HISTORIC AND DESIGN REVIEW COMMISSION

HDRC CASE NO: 2022-303
ADDRESS: 226 E HUISACHE AVE
LEGAL DESCRIPTION: NCB 3086 BLK 2 LOT 7
ZONING: R-4 CD, H
CITY COUNCIL DIST.: 1
DISTRICT: Monte Vista Historic District
APPLICANT: Nadav Givoni/GR-226 HUISACHE LLC
OWNER: Nadav Givoni/GR-226 HUISACHE LLC
TYPE OF WORK: Window replacement
APPLICATION RECEIVED: May 01, 2022
60-DAY REVIEW: Not applicable due to City Council Emergency Orders
CASE MANAGER: Hannah Leighner
REQUEST:

The applicant is requesting a Certificate of Appropriateness for approval to replace nineteen (19) existing wood windows with new wood windows.

WEST ELEVATION

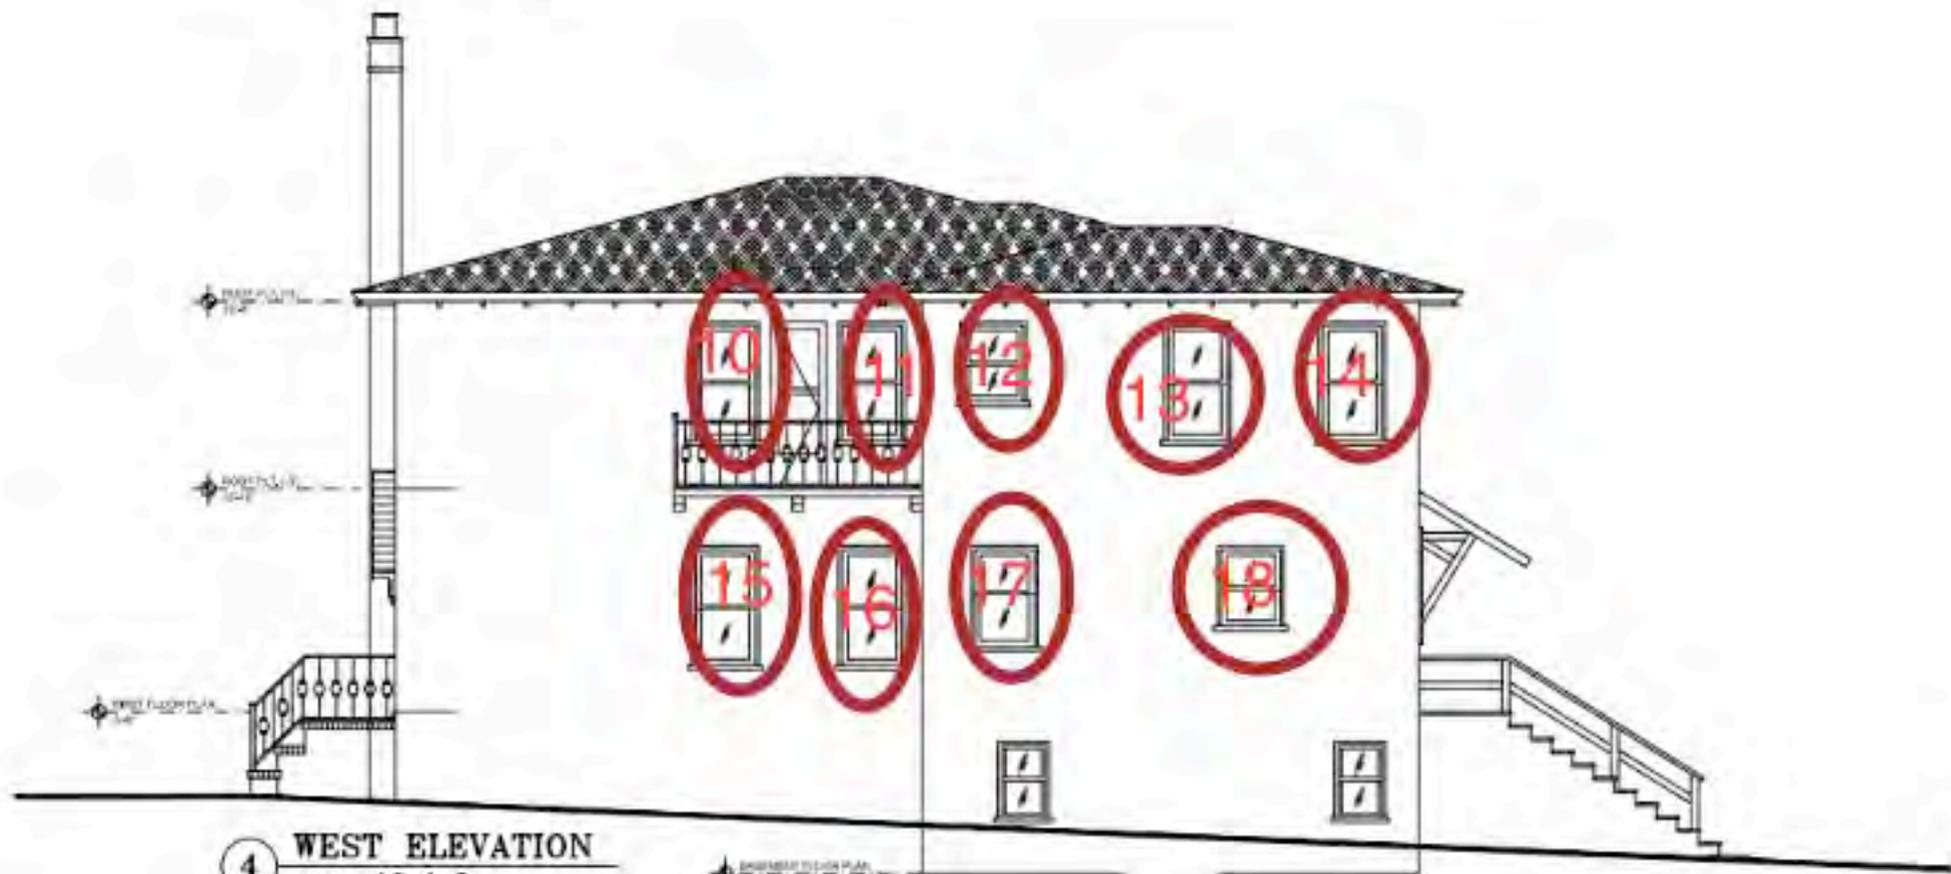
- b. **WINDOW REPLACEMENT: WOOD WINDOWS** – The applicant has proposed to replace nineteen (19) existing wood windows with replacement wood windows. The windows requested for replacement are located on the north, south, east, and west elevations. According to the Historic Design Guidelines, wood windows should be repaired in place and restored whenever possible, unless there is substantial evidence that the windows are deteriorated beyond repair. Guideline 6.B.iv for Exterior Maintenance and Alterations states that new windows should be installed to match the historic or existing windows in terms of size, type, configuration, material, form, appearance, and detail when original windows are deteriorated beyond repair.

- c. **WINDOW REPLACEMENT: EXISTING CONDITION** – From the photos submitted to date, the wood windows proposed for replacement appear to be of historic-age, fully wood one-over-one windows. The windows do not show signs of significant wood rot, wood damage, or severe deterioration. Staff finds that the wood windows are in repairable condition based on the documentation provided, with most requiring minimal repair and intervention such as the reworking of the sashes and re-glazing, along with refitting into the trim and frames. Staff has scheduled a site visit with the applicant for Monday, May 30 and may be able to report additional information at the hearing.

Staff does not recommend approval based on findings b – e. Staff recommends that the applicant restore the deteriorated wood windows and preserve all original window openings.

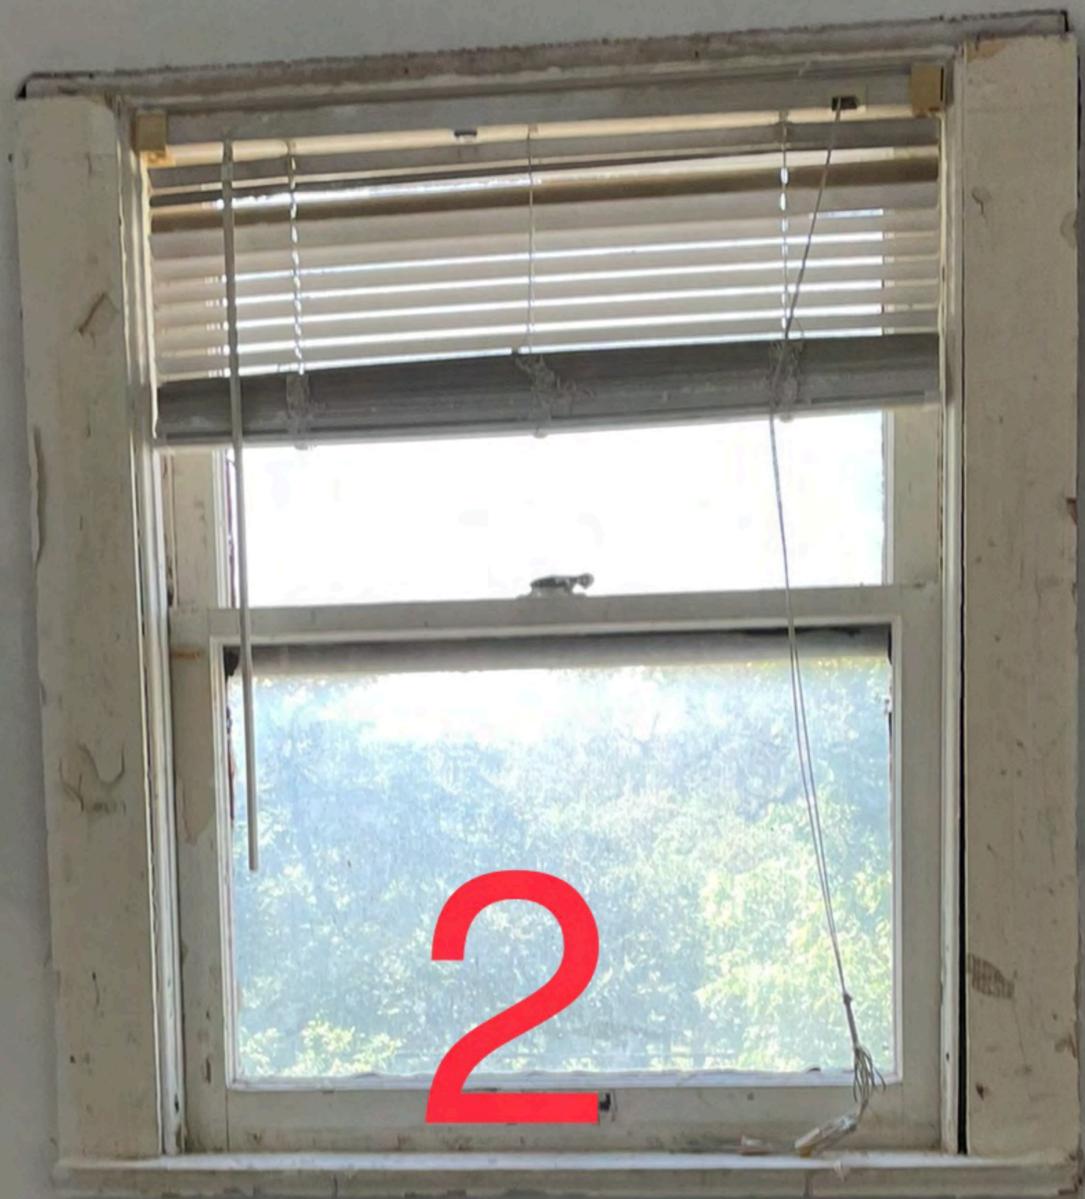
The current condition of the windows is such that many are unrepairable. I've had multiple contractors visit the site and have commented as such. I need to replace them with comparable Marvin windows that are approved for historic window replacement.
